DATE: September 16, 2014 **ST-021-14**

SUBJECT: UTEC ICB Ground Wire

UNITS: 3 6 ton Small Sunline Produced January 1, 2008 through July 3rd, 2014

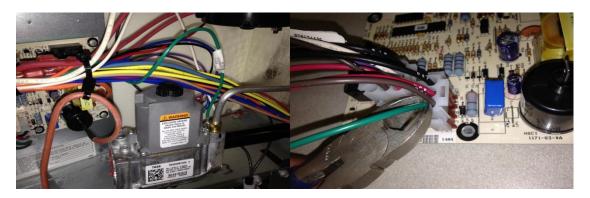
We have experienced isolated cases where ignition is delayed due to low gas line pressures, cold/stiff gas valves or poor building electrical grounding systems. As a result of these conditions, the MV may be delayed. The high voltage spark will continue until the pilot has stabilized and the command for MV has been initiated. The failure event occurs when the spark energy travels back up the pilot tube through the gas valve casting to the green ground wire and back to the ignition control board (ICB).

Extensive testing was conducted with field installed units, factory test units and with UTEC. Testing has confirmed that spark energy seeking earth ground reference to the ICB triggers a safety lockout feature of the control. The board will enter total lockout and will not have fault lights or function. Cycling power will reset the ICB.

Remove the "green" ground wire attached to the gas valve going to the ICB harness. Remove all power to the unit, and using a pair of diagonal cutters, carefully snip the green wire from the back side of the Molex plug on the ICB. Be careful not to "nick" the brown 24v common wire in the same connector location. Unplug green wire from the gas valve and discard.
